City of Hamilton
PUBLIC WORKS COMMITTEE
AGENDA

| 8.1 | Woodward Water Treatment Plant Phase 2 Upgrades (PW22078(a))

TO:	Chair and Members Public Works Committee
COMMITTEE DATE:	June 17, 2024
SUBJECT/REPORT NO:	Woodward Water Treatment Plant Phase 2 Upgrades (PW22078(a)) (City Wide)
WARD(S) AFFECTED:	City Wide
PREPARED BY:	Stuart Leitch (905) 546-2424 Ext. 7808
SUBMITTED BY:	Nick Winters Director, Hamilton Water Public Works Department
SIGNATURE

the success of the Water Treatment Plant Phase 2 upgrades. The Review Assignment was completed utilizing a due diligence approach, focusing on a review of the 2022 Phase 2 Conceptual Design components. The following is a summary of the Review Assignment findings:

Figure 4-1: Proposed UV Building Infrastructure and Layout (Source: AECOM Conceptual Design, 2021)

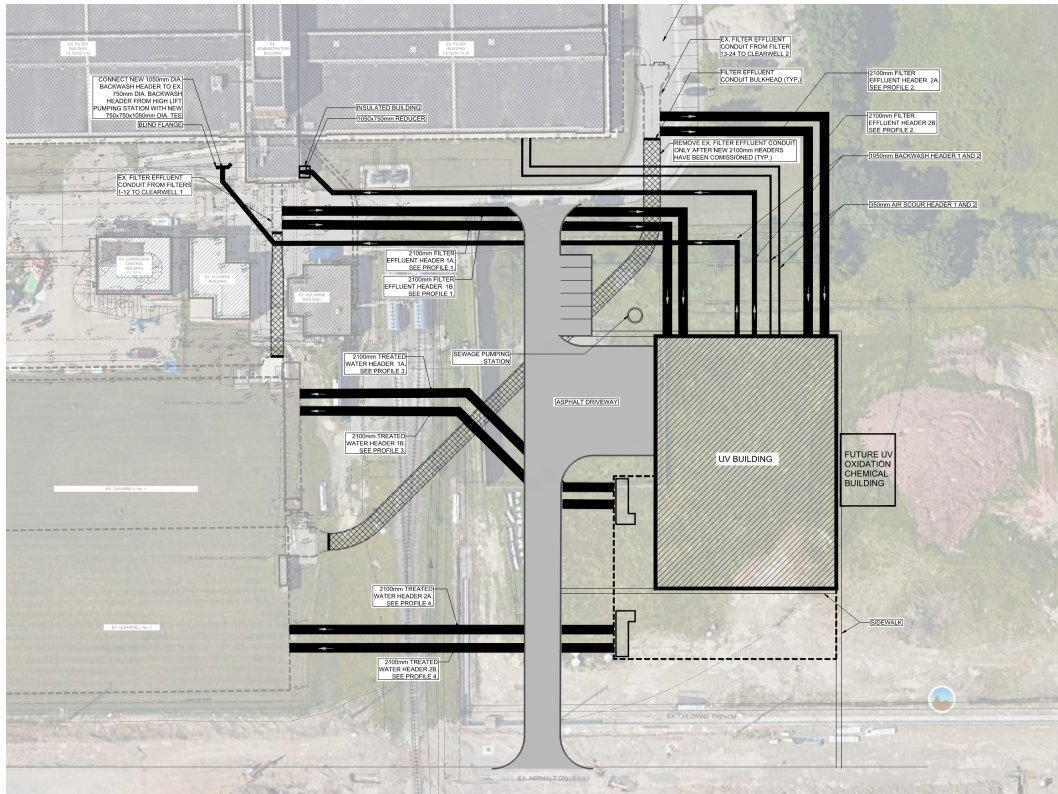
The below image (**Figure 4-1**) is the UV Building in the proposed location complete with all major new infrastructure connecting it to the existing treatment train. At first glance, the piping arrangement appears to be convoluted, where portions can be deleted in full, and others simplified. It is worthwhile clarifying that we have assumed that all major pipe systems have been twinned to eliminate single points of failure concerns the City might have within the treatment process.

The UV outlet at the southerly portion of the building connecting to existing Clearwell No. 2 results in an unnecessarily long downtime to Clearwell No. 2. The City has already completed modifications that permit flow into either clearwell through one common influent channel. It should be noted that based on the current CT calculator, the City does not count CT provided through the clearwells, therefore without clearwell 2 in operation, there is no impact to plant capacity.

After having reviewed the site piping layout, we believe replacing the pipe system with a cast-in-place (CIP) concrete split conduit would better serve the City by minimizing the amount of downtime required for connections.

Figure 4-5: FTW Piping Conceptual Design (Source: CH2M Filter-to-Waste report, 2021)

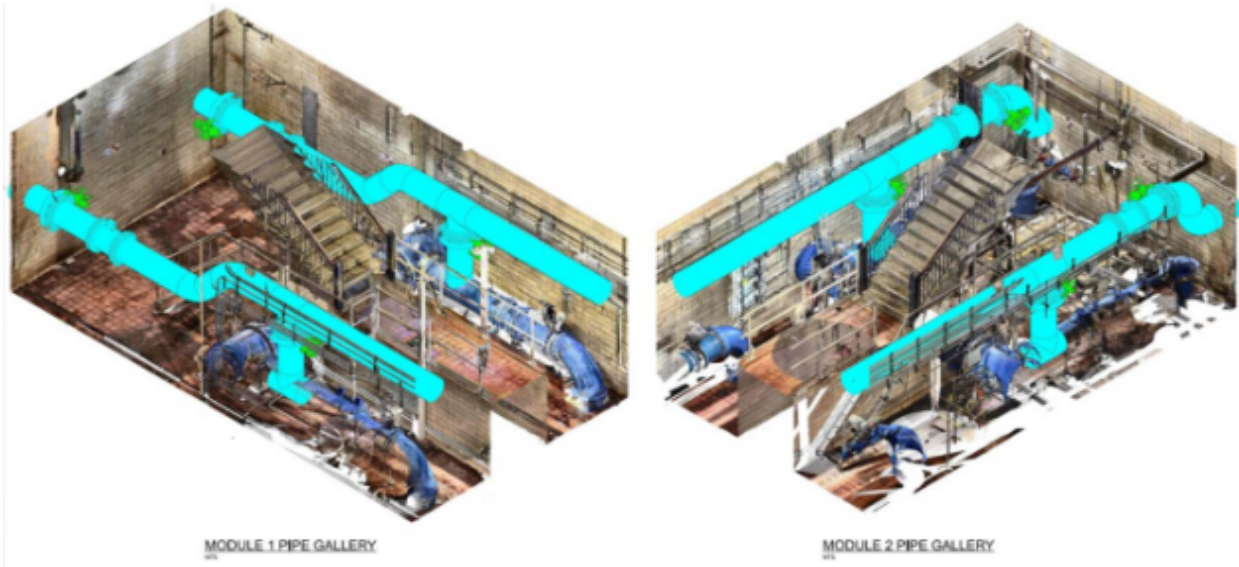
There are concerns regarding how this piping would integrate into this area of the plant that is already a very old build and having its own degradation issues. During our November 18, 2022 site visit, there were signs of water weeping up through the floor tiles, hollow sounding floor tiles indicating issues below, concrete spalling, and reinforcing steel corrosion.

At face value, integrating the FTW piping within this pipe gallery may appear to be the easiest way to implement the system, but it will not be without careful staging within a congested area as shown in the photo in **Figure 4-6**.
